### **Keith Bridge Project Cycling Facilities**

## Keith Bridge project cycling infrastructure recommendations

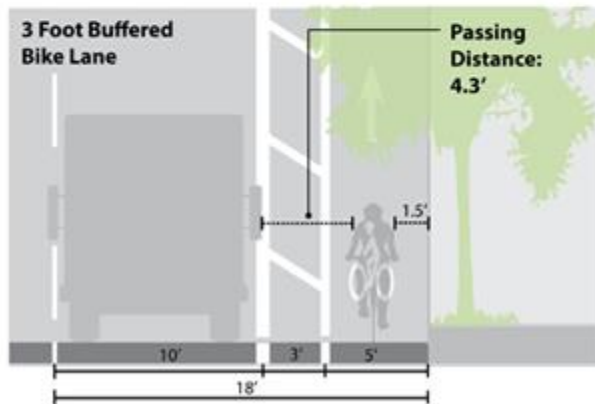
- The figure on the next page shows that a 1.8 metre bike lane as originally planned for Keith Road, would provide a passing distance of less than 0.8 metres to buses and trucks (since the vehicle lane on Keith would be slightly narrower than in the figure). US states and countries with safe passing laws recommend a passing distance of at least 0.90 metres to 1.5 metres.

1.8 m bike lane without buffer  
3.65 m vehicle lane  
Passing distance: 0.85 m

1.5 m bike lane with 0.6 m buffer  
3.35 m vehicle lane  
Passing distance: 1.15 m

1.5 m bike lane with 0.9 m buffer  
3.05 m vehicle lane  
Passing distance: 1.3 m

- If the bike lanes are not protected, they should at the very least be buffered to increase the passing distance between bikes and motor vehicles. We recommend a 1.5 metre bike lane with a 0.9 metre buffer to increase safety and use of the bike lanes.
